Staff Presentation to the
Portland Design Commission

LU15-265477 DA
1732 NE 2nd Avenue, Mixed-Use

January 28, 2016

MOD #1 Height Standards (33.130.210.B.2)

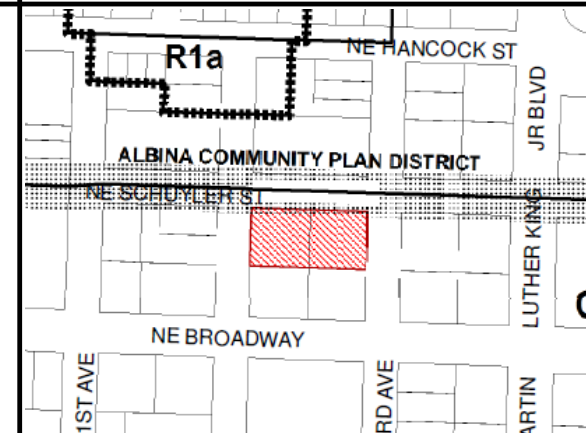
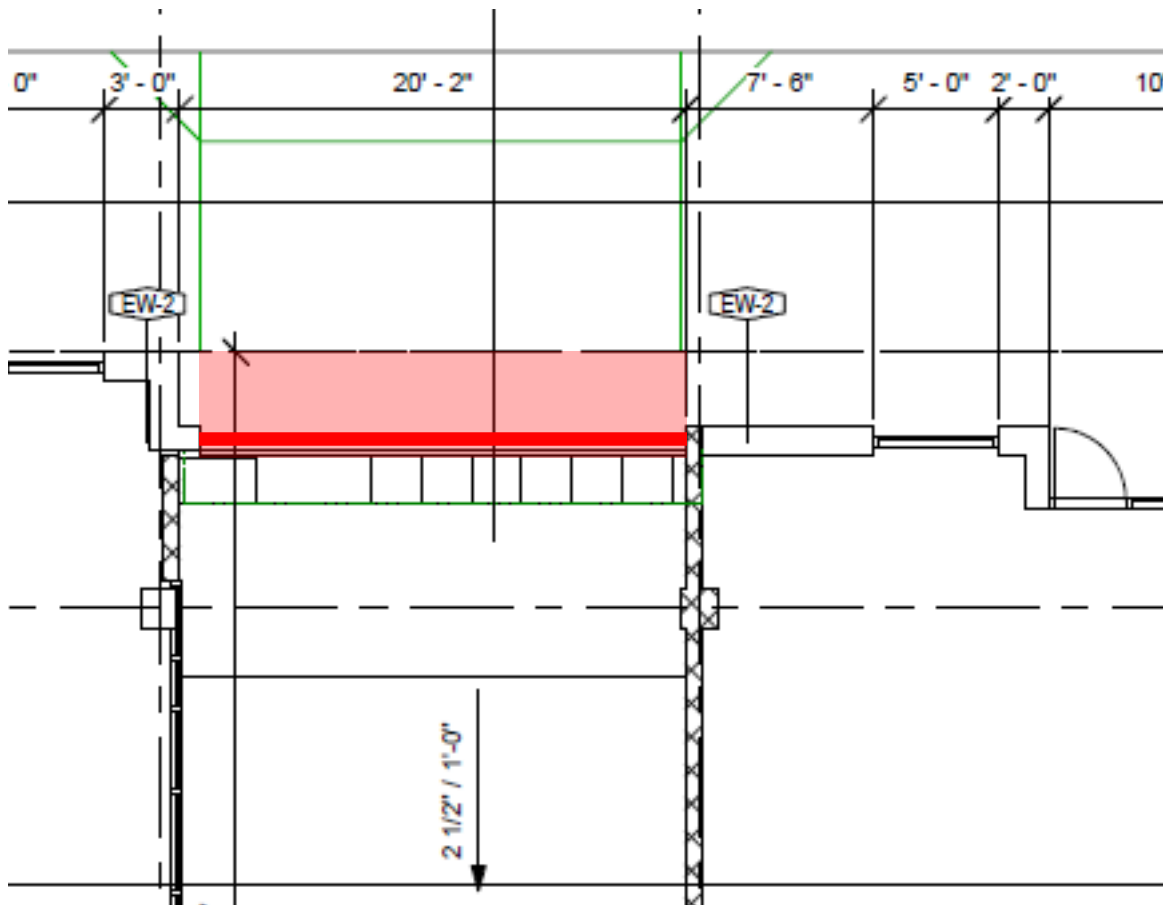
Proposal indicates parapet at 99'-10", very close to 100' maximum limit.

Rooftop installations shown may not meet the height exemption limitations of 15' setback from roof edges, 10% coverage and 10' maximum height.

Design Exception for **Garage Door Setback**

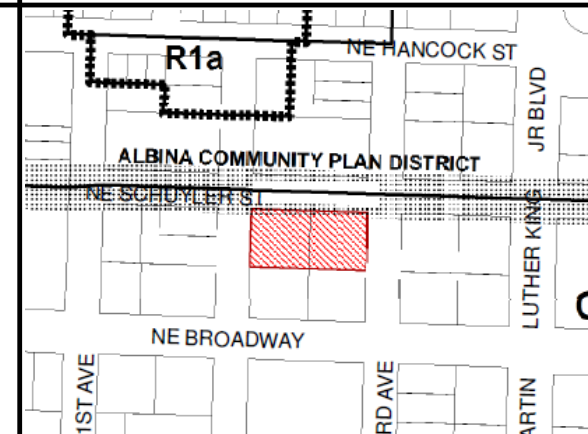
Proposal indicates door at about 4'.

PBOT requires driveway gates to be located 20 feet beyond the back of the sidewalk. A design exception is required though PBOT to locate gate closer.

1. Height & Massing

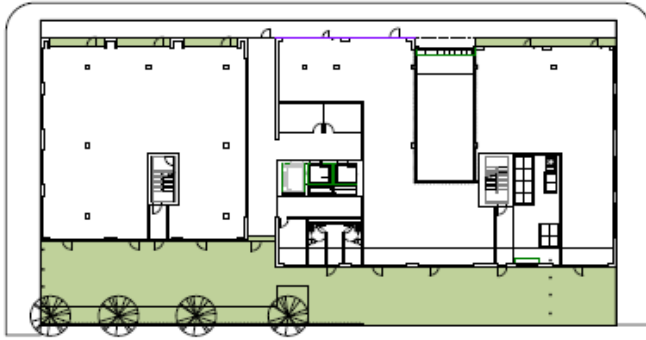
Does the proposed design reflect the transitional nature of this site?

Quality of terraces provided?

Amenity space for 141 residents?

3. Pedestrian Protection

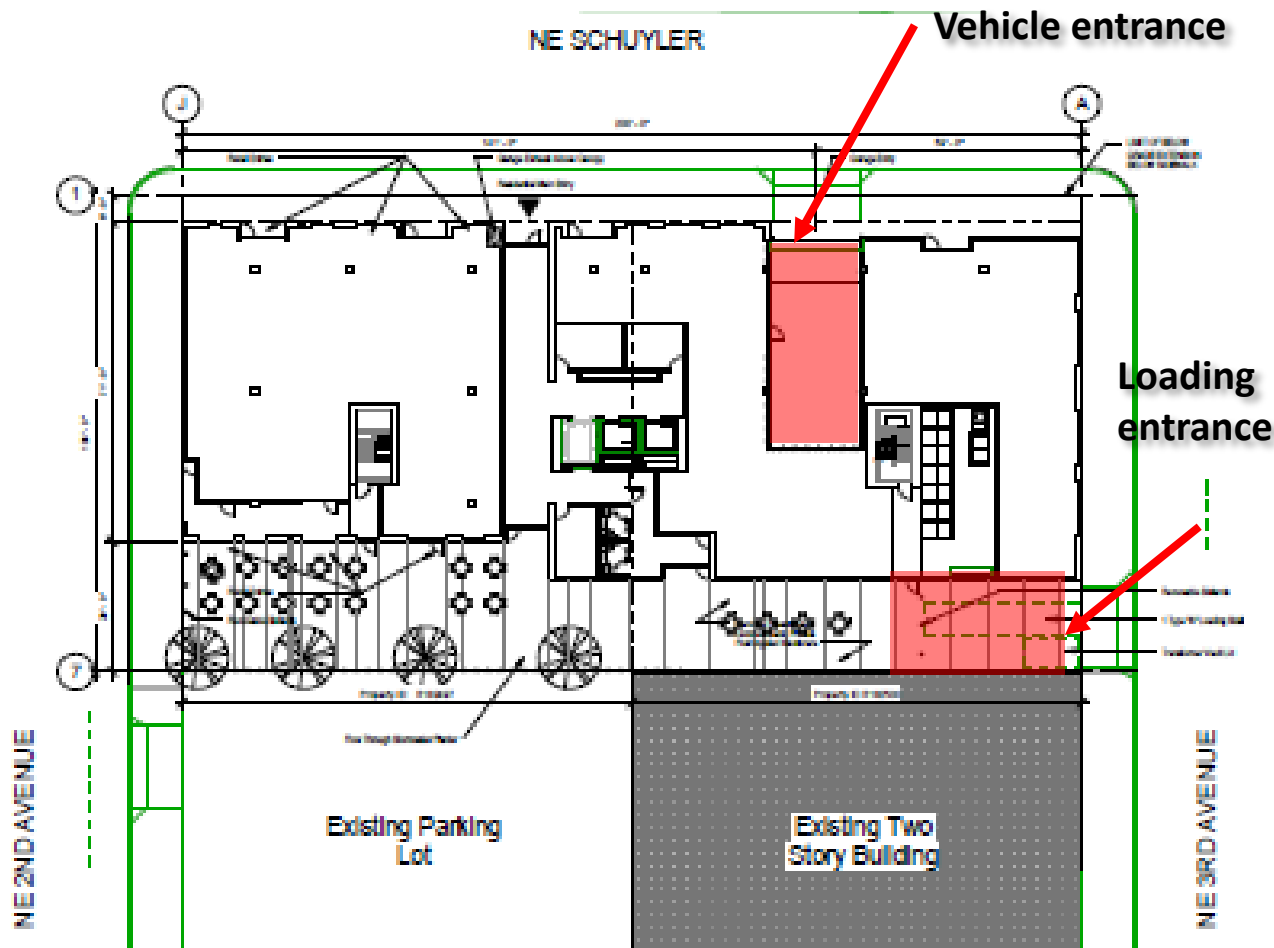
Does the proposed design provide sufficient pedestrian protection on all three street frontages?

NE SCHUYLER

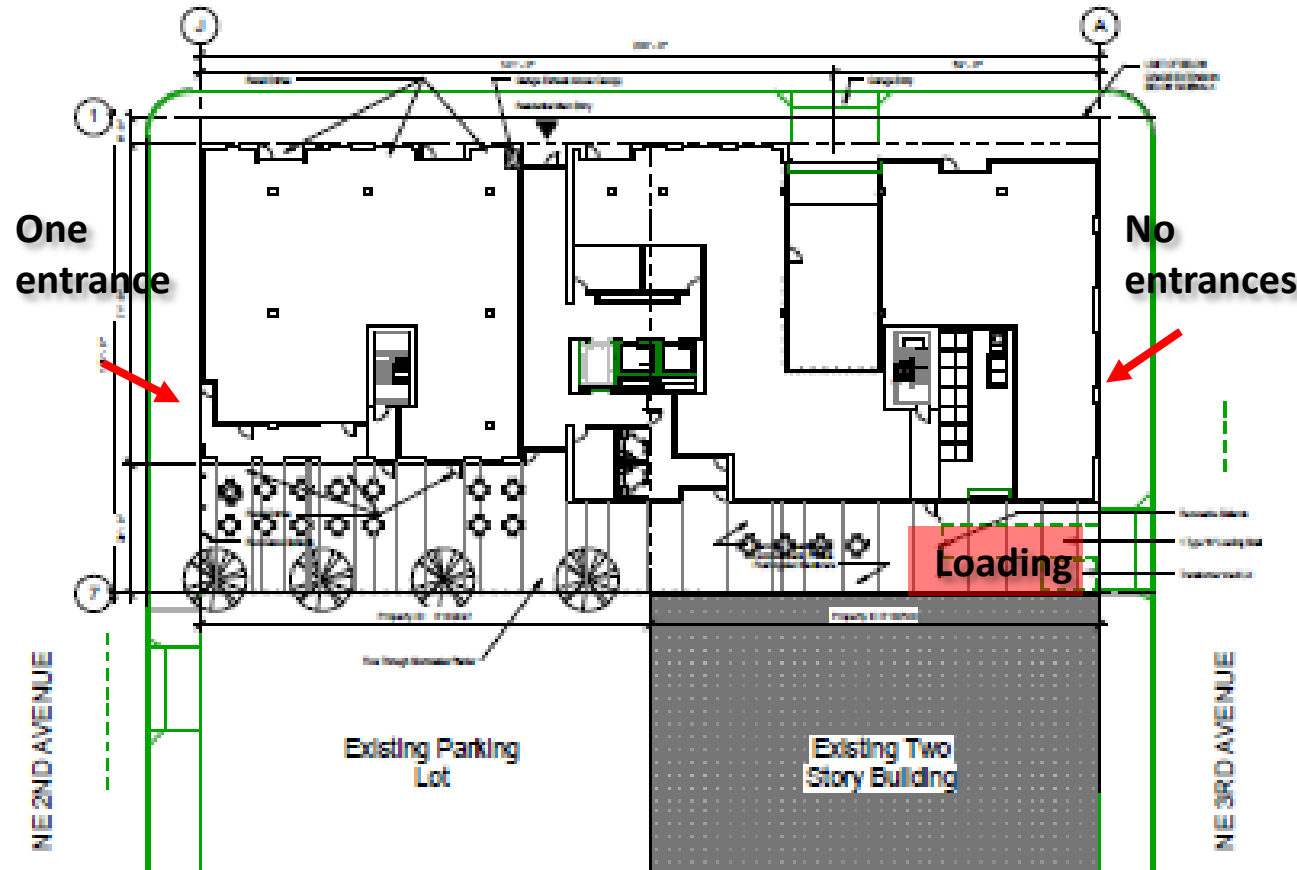
Would the proposed vehicle entrance be better located off NE 3rd, possibly sharing the curb cut there?
